JAPAN's Comments

Informal document GRSG-102-34
(102nd GRSG, 16-20 April 2012
agenda item 6)

On OICA document Submitted by the expert from OICA

On Informal document No. GRSG-102-xx Submitted by the expert from Germany

Diagram [16] refer;GRSG-101-27 P10 ;N3

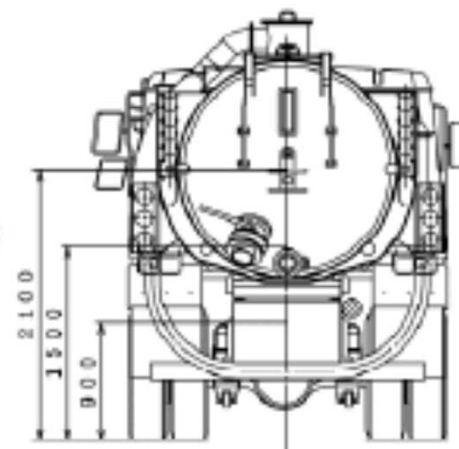
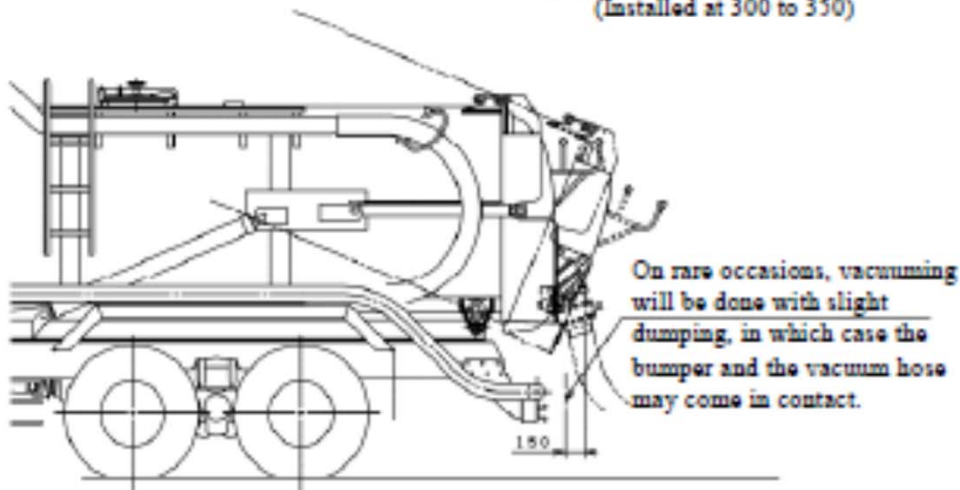
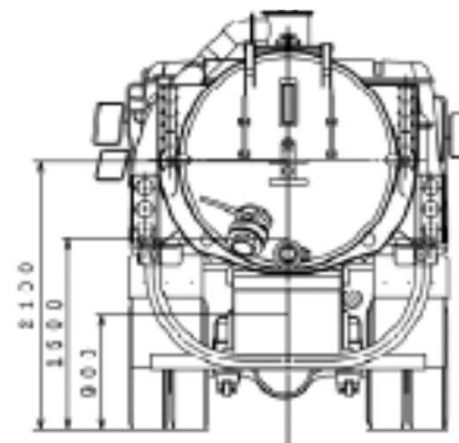
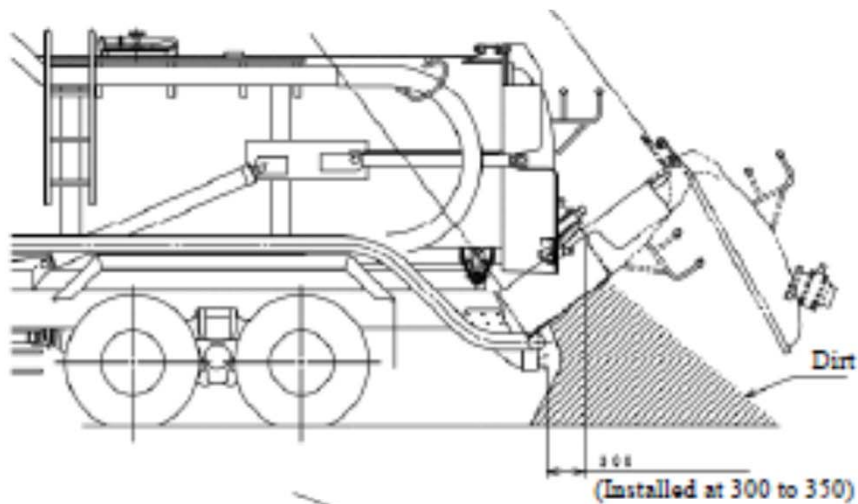
Cases where the RUPD installation position of 200 mm (from the rearmost part of the vehicle) will cause difficulties in usage

Vacuum Trucks: When the truck dumps the load, it will come in contact with the RUPD, making the dumping work difficult. With the RUPD being located too close to the vacuum hose, handling of the hose will be difficult when the truck vacuums the load.

Diagram [17] Dump trucks, Concrete mixer trucks refer;GRSG-101-27 P9 ;N3
Cases where the RUPD underside height of 500 mm will cause difficulties in usage (Dump &Concrete mixers)

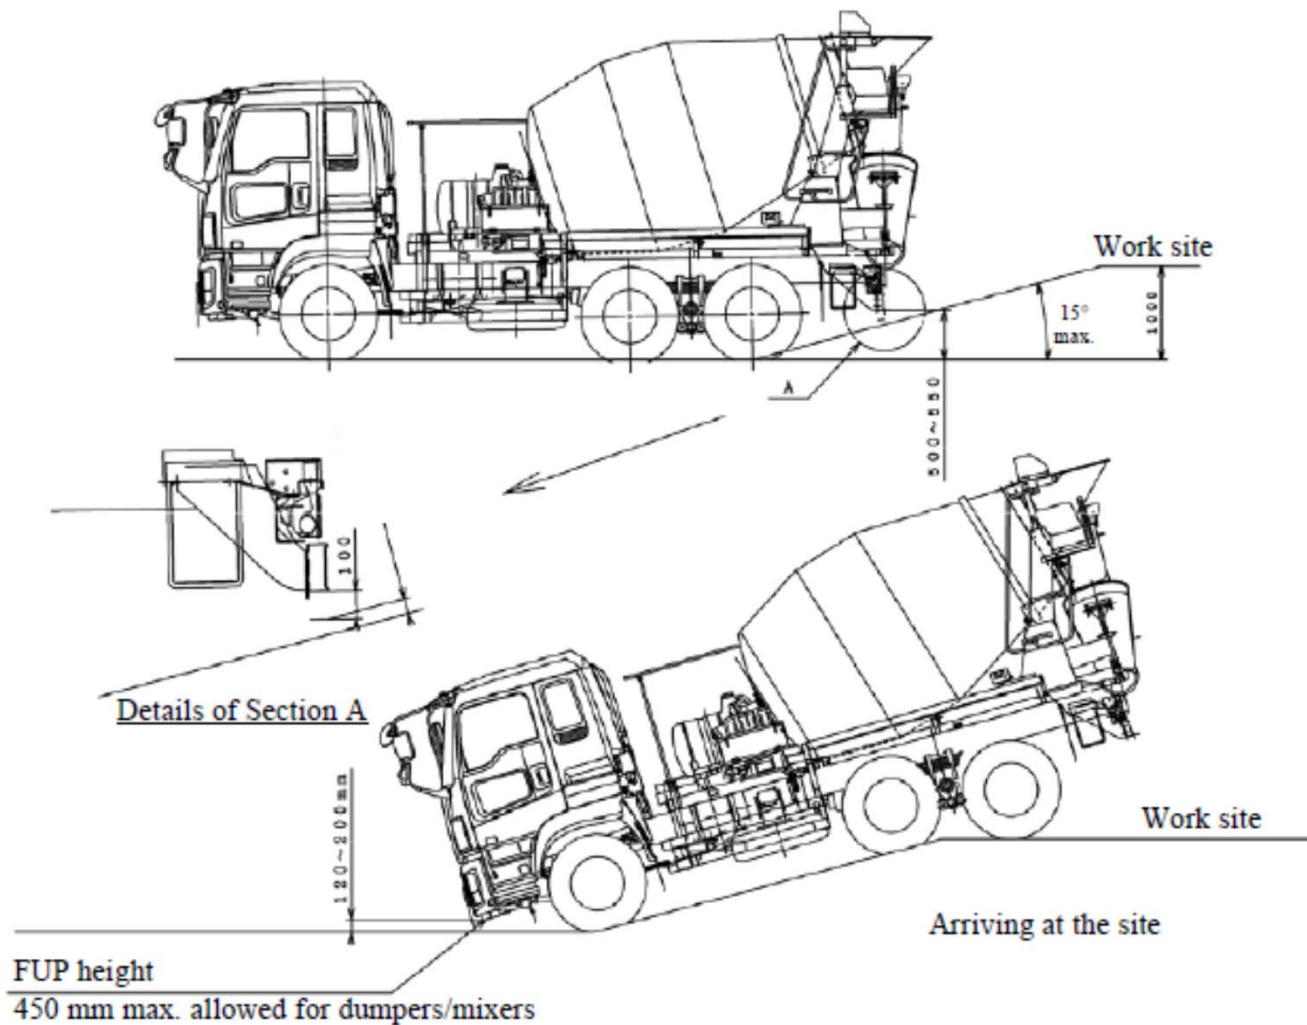
In Japan, some of these vehicles are stored on hills, where the maximum gradient can be around 15°. The RUPD will come in contact with the road surface while the vehicle is running, making it unable to keep running to enter the site.

Diagram [18] Vehicles that come in contact with road surface when entering ;N3 motorway /ferry ramps with a large gradient (8 deg.) (Departure angle of 8 deg. or more is necessary.)

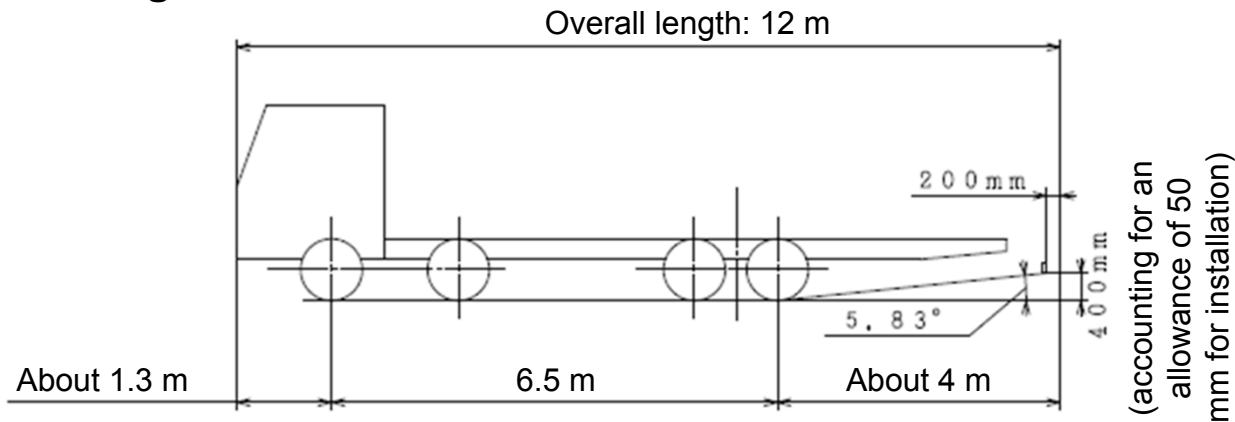
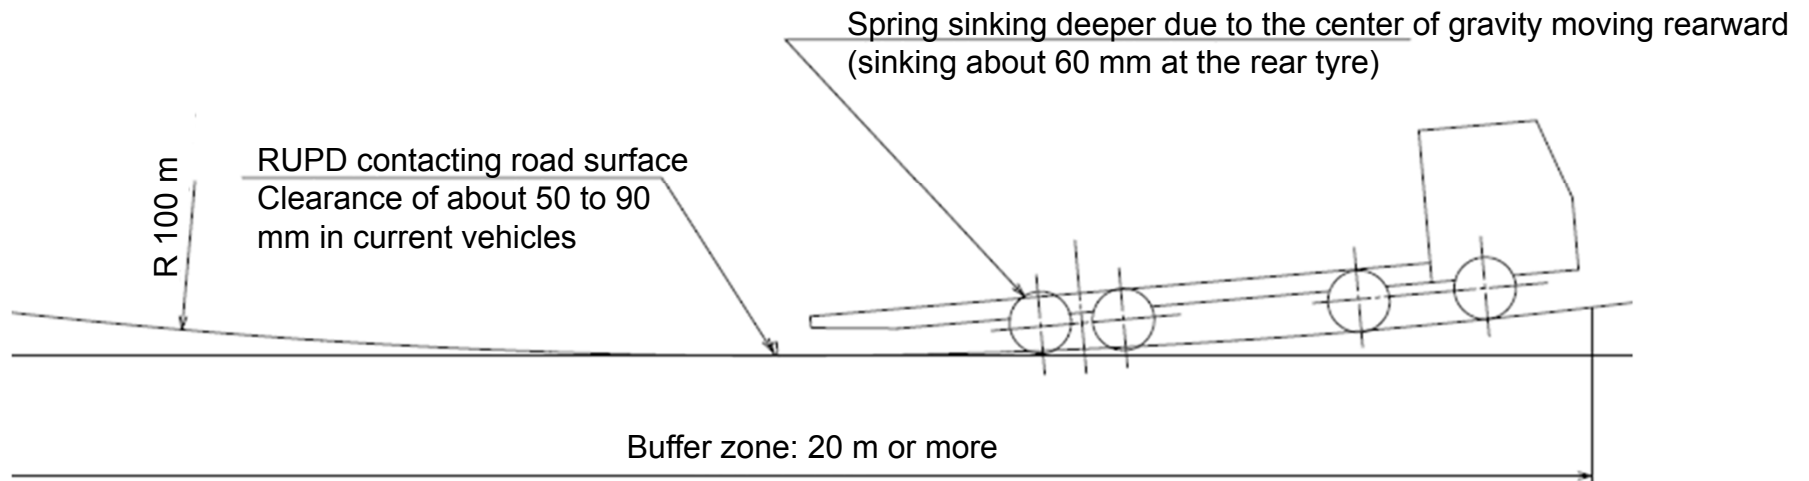
Cases where the RUPD installation position of 200 mm will cause technical problems in constructing the vehicle structure

Large vehicle running on road with 12% gradient (6.8 deg.) fore and aft

Diagram [19] refer;GRSG-101-27 P2

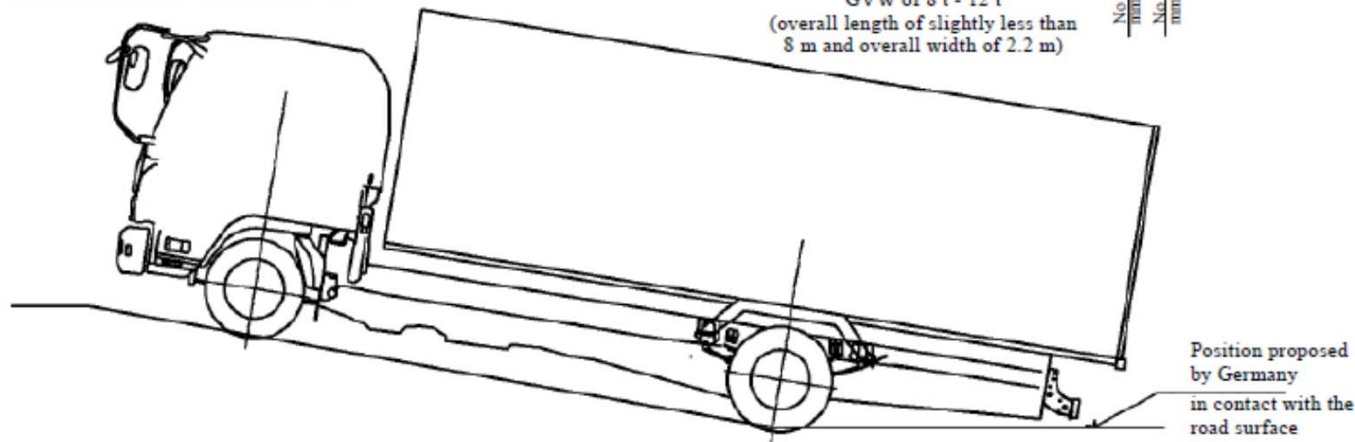
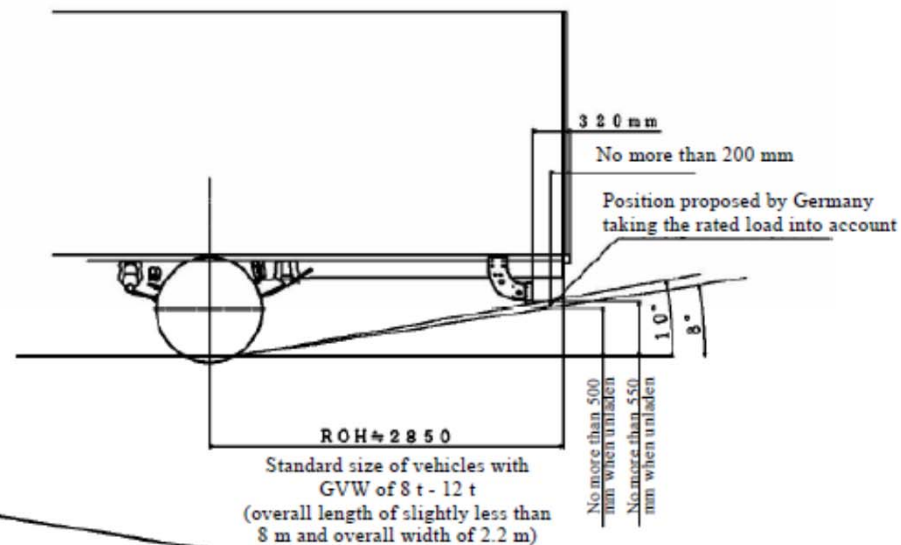
Cases where the departure angle of 10° or above is necessary

From the standpoint of practicability on the market, the departure angle of 10° is specified. If it is 8°, the RUPD will come in contact with the road surface while the vehicle is running, making it unable to keep running. For medium-sized vehicles, some manufacturers in Japan have established voluntary regulations regarding the departure angle as these vehicles often enter parking lots and/or narrow streets. (The cases where they came in contact with the road surface at a departure angle of 9° or below have been reported.)

Diagram [20] refer;GRSG-101-27 P3 ;N2

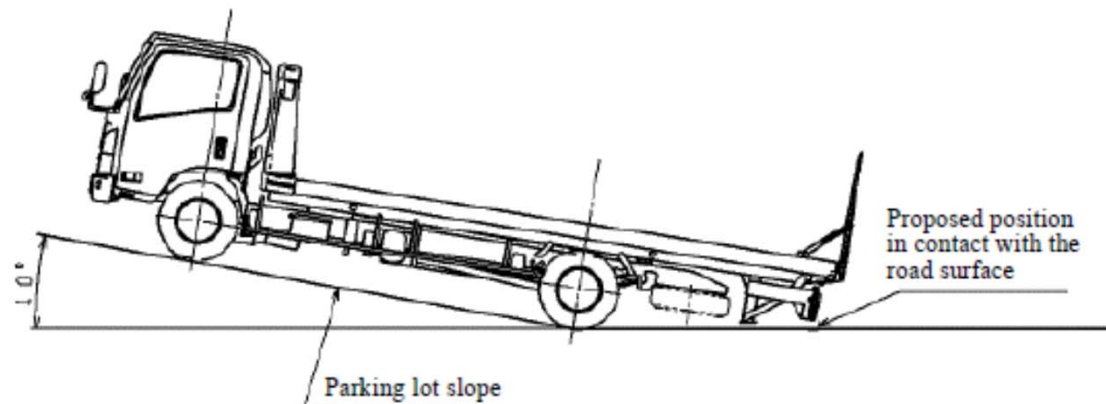
Cases where the departure angle of 10° or above is necessary (Car carrier vehicles)

The RUPD will come in contact with the road surface while the vehicle is running, making it unable to keep running. (The device will come in contact with the road surface when the vehicle enters parking spaces in urban areas, etc.)
